DA NO: DA0490/2017  
 APPLICANT: LC Kettle  
 LOCATION: 27 Benvenue Road  
 ST LEONARDS  
 PROPOSAL: Residential - single dwelling;  
 construction of retaining wall  
 on boundary (retrospective)  
 CONTACT: Iain More  
 Ph: (03) 6323 3000  
 DATE OF NOTICE: 07/10/2017

**RE: Development Application DA0490/2017 (City of Launceston) for 27 Benvenue Road, St Leonards**

SITE PLAN (INDICATIVE ONLY)

Skol

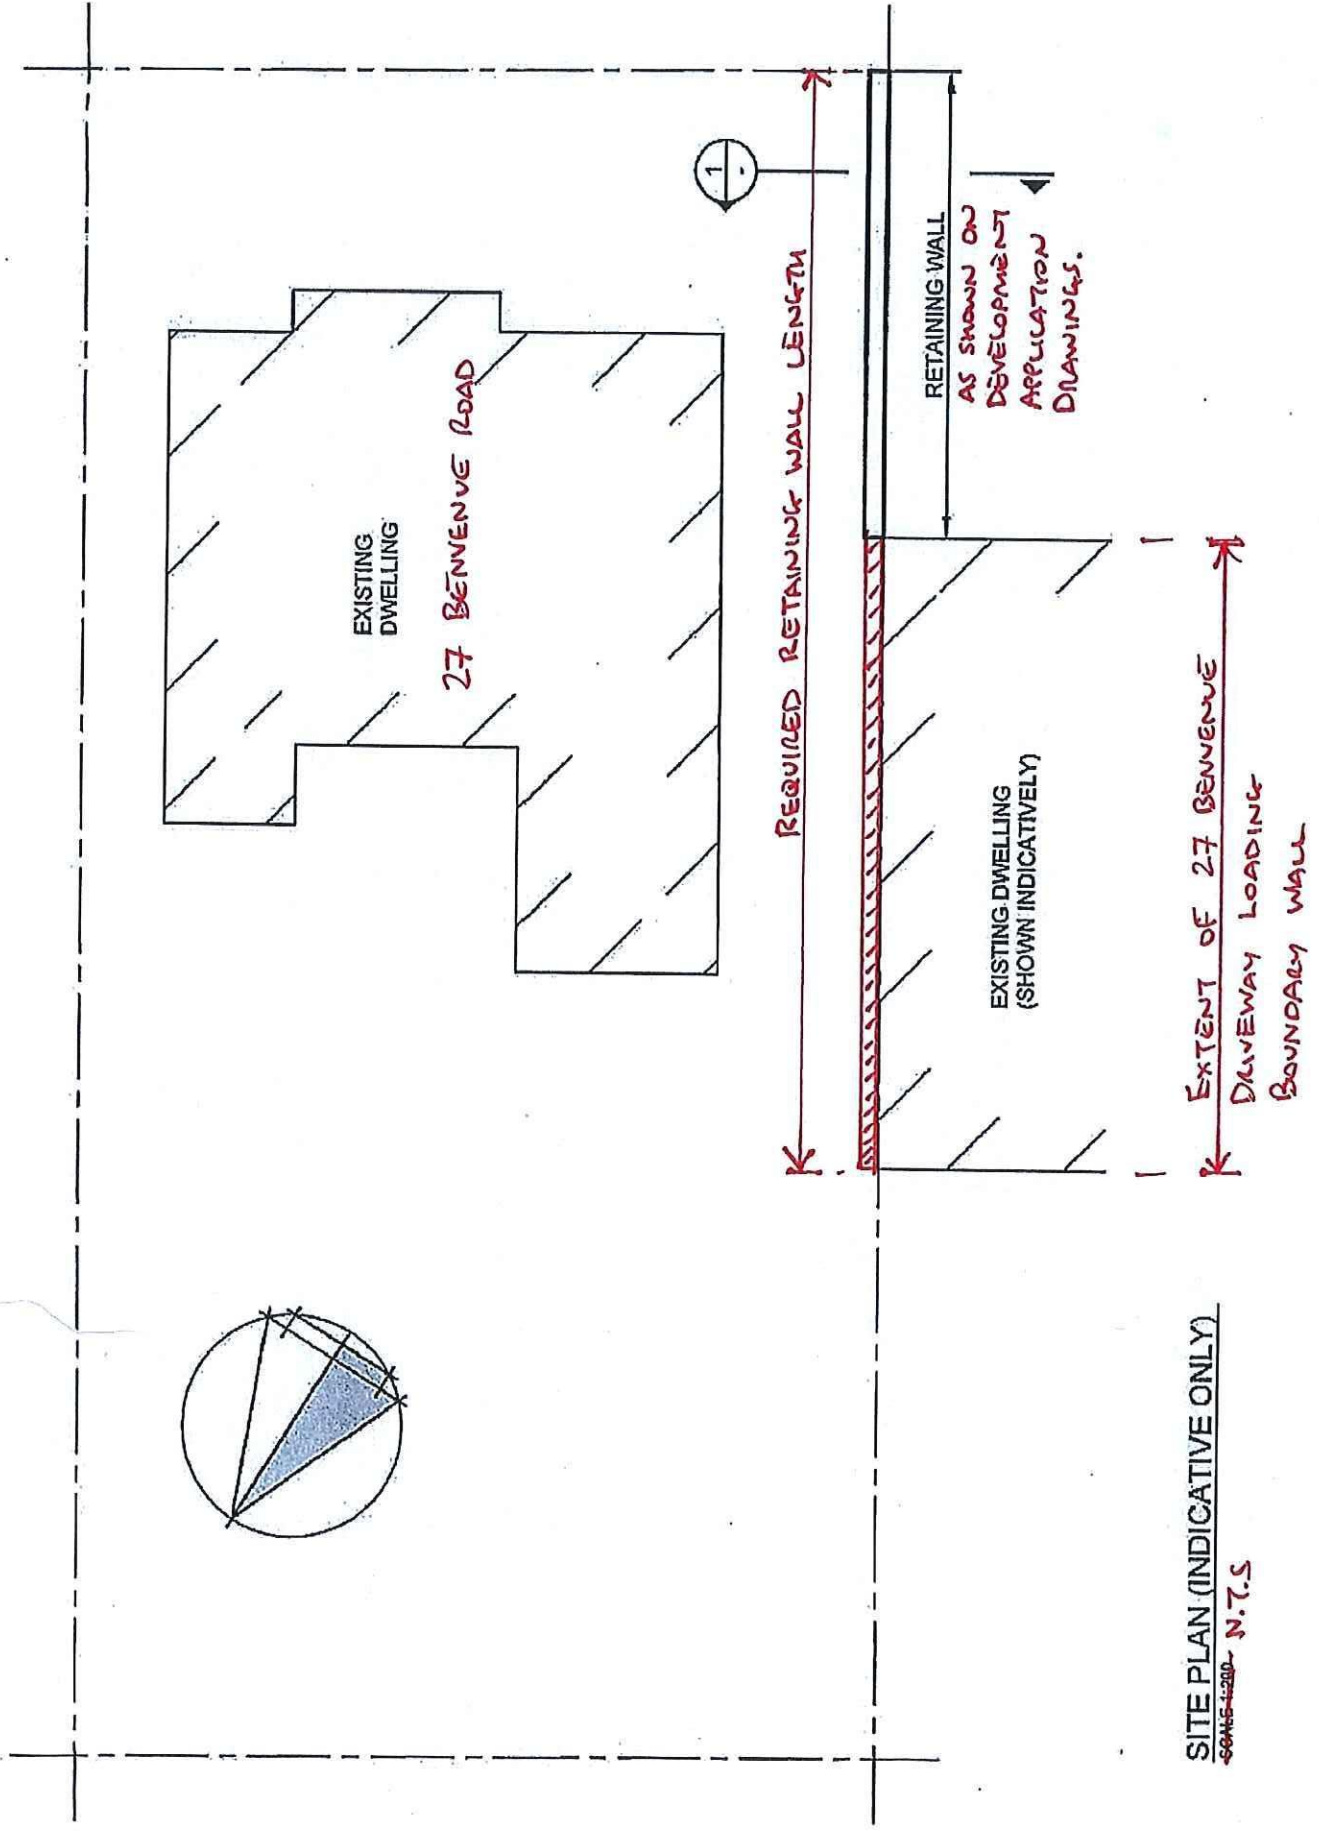
In our opinion, the application does not cover the full extent of structural works undertaken at the 27 Benvenue Road property, specifically the satisfactory support of the concrete driveway adjacent to the boundary wall. The development application drawings show the retaining wall terminating at the south eastern corner of the dwelling, refer attached SK01, leaving the remainder of the concrete driveway to be retained by the boundary wall.

We believe, from a structural perspective, that the retaining wall shown on the development application, should be extended to retain the full extent of the concrete driveway, as shown on the attached sketch SK01, so as not to load the boundary wall.

RETAINING WALL AS SHOWN ON DEVELOPMENT APPLICATION DRAWINGS.

EXTENT OF 27 BENVENUE DRIVEWAY LOADING BOUNDARY WALL

Photo 10 - Example of 'fresh' cracking to south east (front) wall, note location in Appendix B - crack width noted as 1.0 mm.

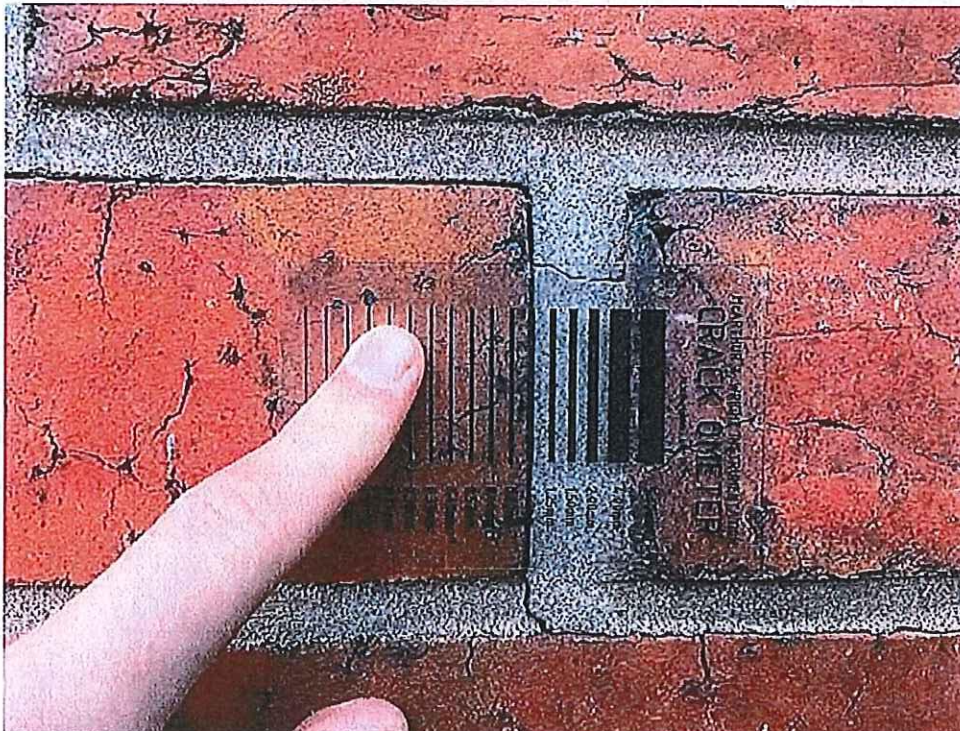
The house was observed to have some external cracking in the brickwork at three locations. Cracks in these locations were measured. The largest crack was approximately 2 mm wide, but otherwise the cracks were generally less than 1.00 mm (refer Photos 10-15 & 21 in Appendix A and Appendix B for locations).

Photo 20 - Sub-floor ventilation on north east boundary wall which has been blocked by construction of neighbouring driveway.

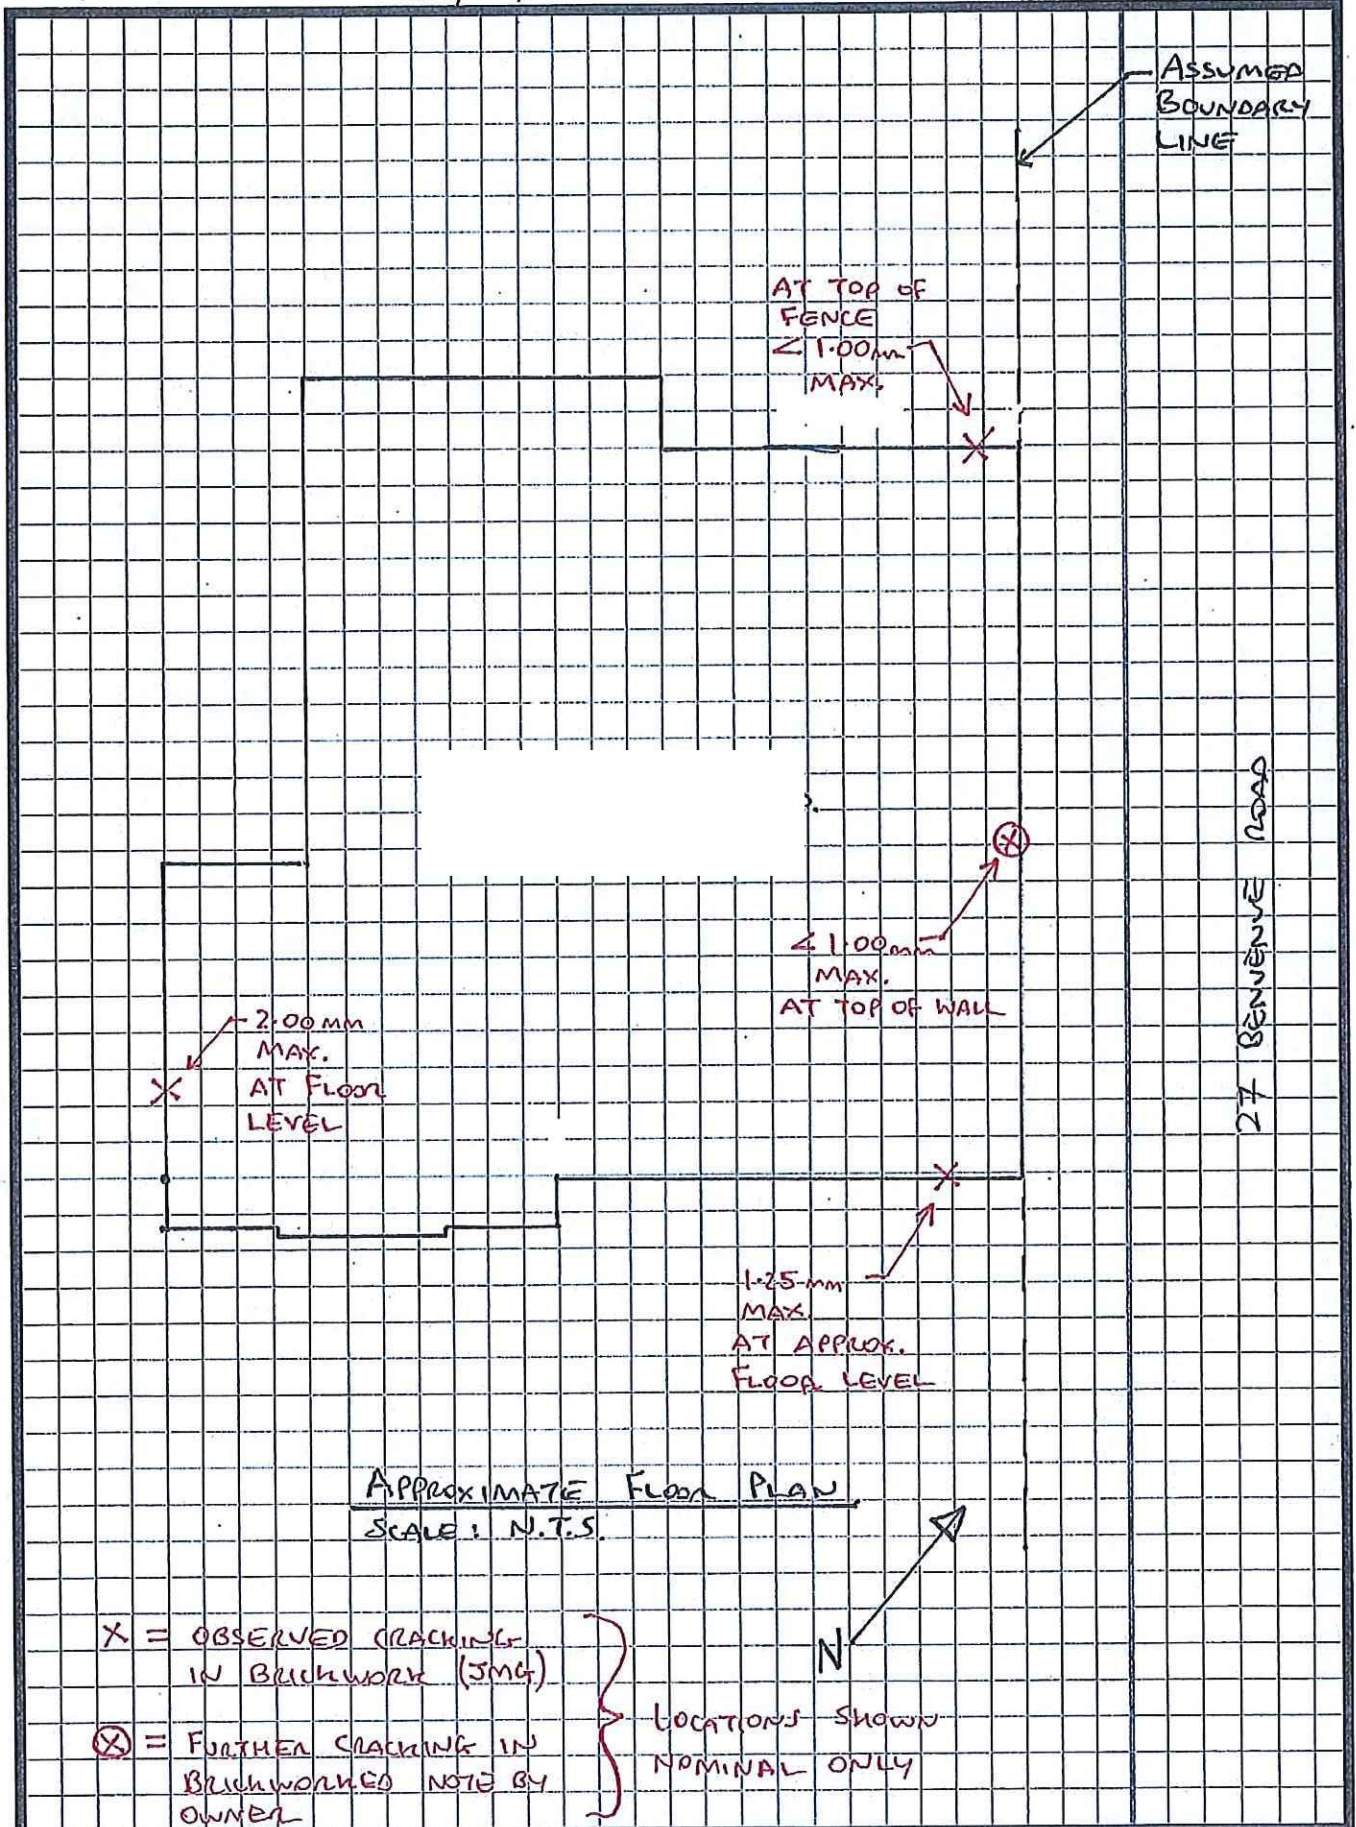
We also note, as per our attached report, that there appears to be sub-floor ventilation on the boundary wall that has been covered by the 27 Benvenue Road driveway works.

During inspection of the sub-floor area, it was noted that sub-floor ventilation on the boundary wall has been covered as part of the construction works at 27 Benvenue Road (refer Photo 20 in Appendix A). It was also noted that a block retaining wall within the sub-floor storage area showed signs of movement (see Photo 17 in Appendix A).

10 Goodman Court, Invermay ph:(03) 6332 3700 fax:(03) 6332 7004 email: pc@protek.co.nz	Project <b>CARPORT AND BOUNDARY WALL</b> for <b>MR DARREN WRIGLEY</b>		Drawing <b>AS CONSTRUCTED AND PROPOSED</b>	Scale 1:30	Copyright ©
	Designed PC	Approved PC	Date 16/12/2016	Down PC	Project/Drawing 5269-0001

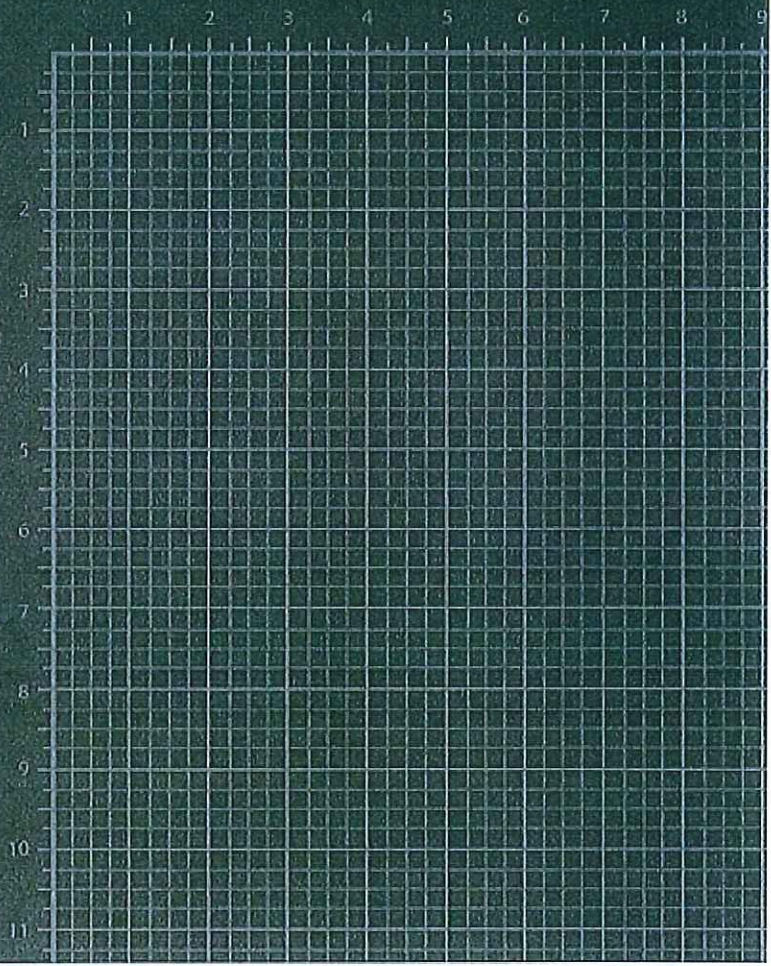
Mr. & Mrs. Wrigley supplied the attached (refer Appendix C) *Protek* report *Structural Survey (Boundary Wall)*, including drawing 5269-0001. This drawing shows the assumed existing situation and also a proposed engineered retaining wall solution. We generally concur with the *Protek* drawing and report, other than that no engaged piers along the boundary wall were noted and that floor joists not bearers were present in the location shown, with these being supported in a recess in the inside skin of brickwork (refer Photo 19 in Appendix A).

3. If it is confirmed that the driveway has been constructed as per *Protek* drawing in Appendix C, we recommend that the driveway construction should be removed. If the driveway structure is to be rebuilt in an acceptable fashion, it should be constructed so as to satisfy the *Building Code of Australia* and the relevant *Building Regulations*. We recommend that the design be prepared by a suitably qualified Engineer.

1. Partial removal of the existing concrete driveway;
2. Provision of detailed engineering drawings detailing a suitable retaining wall structure to retain fill under the driveway and to ensure ground water that may build up behind the retaining wall is directed to storm water and away from the neighbouring property.
3. Detail of how the existing concrete slab is to be re-supported onto the new retaining wall and detail of how the concrete slab forming the driveway/carport slab is to be separated from the boundary wall brickwork.

A suggested detail is provided to assist in understanding how I would envisage this matter to be resolved (See Appendix D).
